**COMBUSTION ENGINEERING**

Subject: Revision to License Amendment Request  
for Hematite Organizational Changes

**COMBUSTION ENGINEERING, INC.**  
**HEMATITE NUCLEAR FUEL MANUFACTURING FACILITY**  
**REQUEST FOR LICENSE**  
**LIST OF AFFECTED PAGES**

**COMBUSTION ENGINEERING, INC.**  
**HEMATITE NUCLEAR FUEL MANUFACTURING FACILITY**  
**REQUEST FOR LICENSE AMENDMENT**  
**DESCRIPTION OF CHANGES**

**FIGURE II.3-1**  
**HEMATITE PLANT ORGANIZATION CHART**

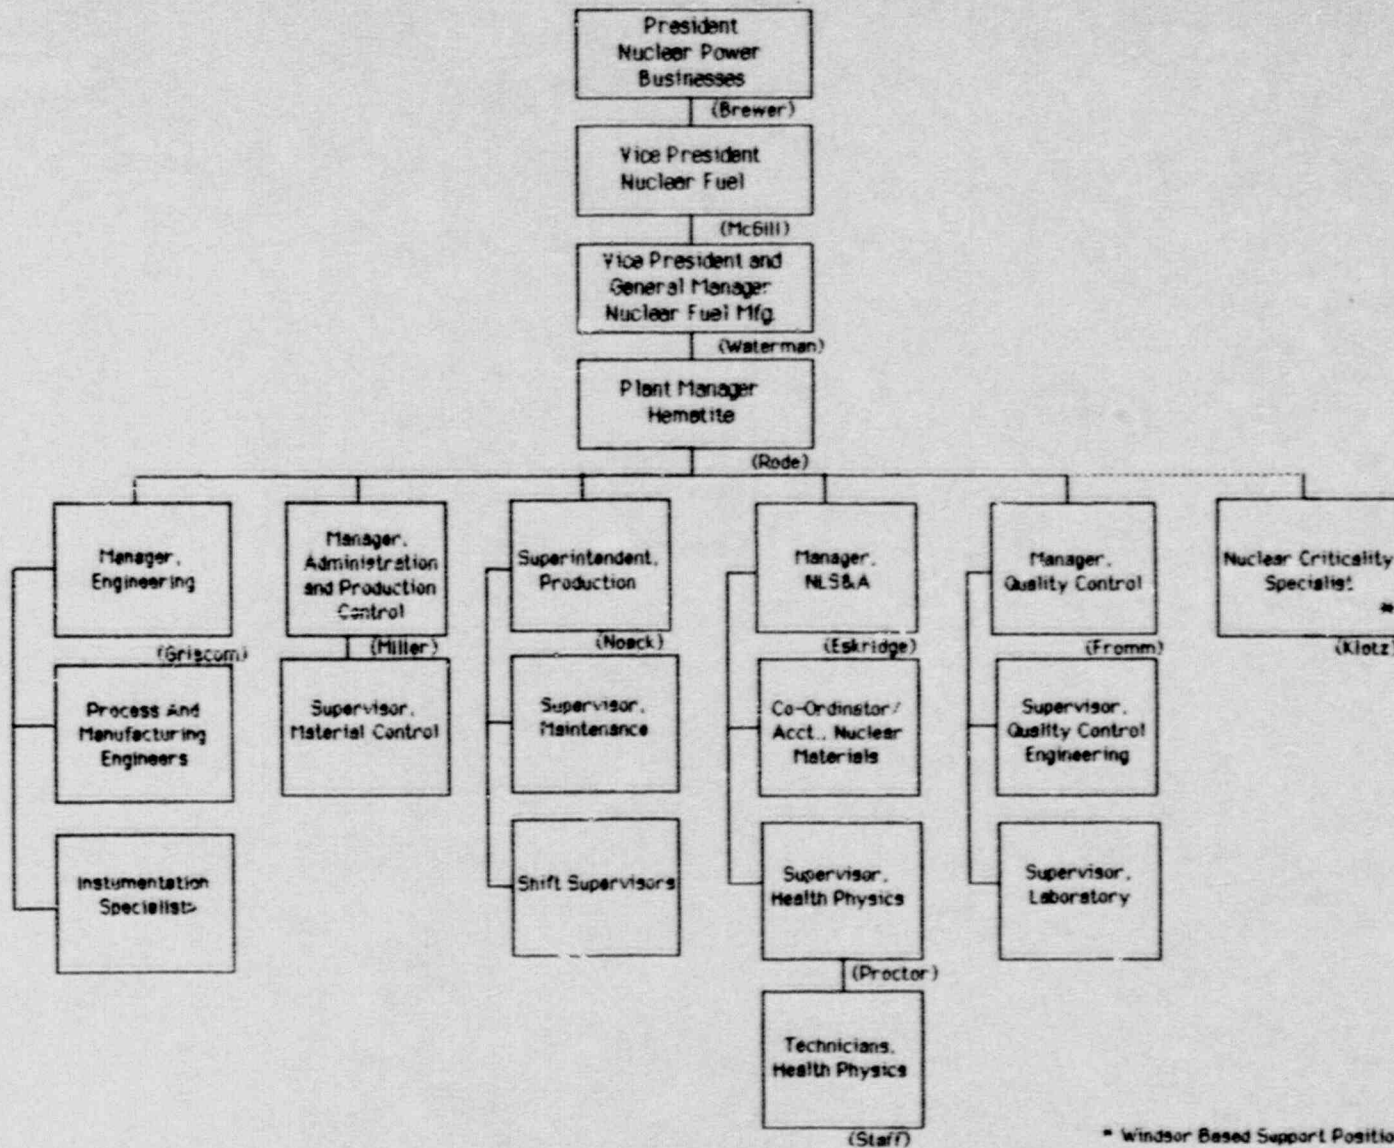
II.3-3	3.2 (formerly Section 3.3)	Delete names and resumes for persons not in positions of key importance to safety.
II.3-5	3.2 (formerly Section 3.3)	Add resumes for Vice President and General Manager, Nuclear Fuel Manufacturing; Nuclear Criticality Specialist; and Supervisor, Health Physics.
-----	(formerly Table II.3-1)	Delete Table II.3-1
II.3-25	Figure II.3-1	Revise Organizational Chart.
